60- and 66-MHz Pentium® Processor Specification Update

Release Date: February 1997

Order Number 243326-001

21. Power-Up BIST Failure

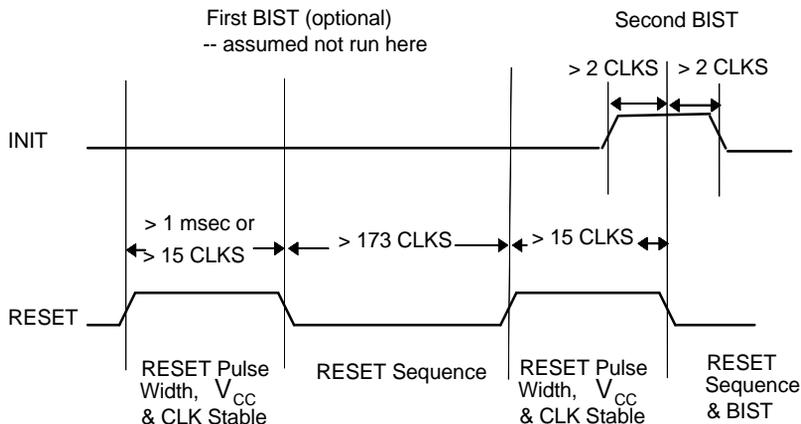
PROBLEM: The BIST (Built In Self Test) feature may fail.

IMPLICATION: Upon completion of BIST, a false failure may be reported. That is, a non-zero value may be returned in the EAX register, even though the part is operating correctly. As such, this erratum has no other product or system implications and is fully functional. To date, all observed false failures have returned a value of 20000H in EAX.

1. Invoke a double RESET — All false BIST failures have occurred during cold RESET. In order to accurately execute BIST, a double RESET sequence may be performed as shown in the figure below:

2. Use RUNBIST — BIST may be run through the RUNBIST instruction, available through the Test Access Port as documented. In this fashion, BIST will return correct values.
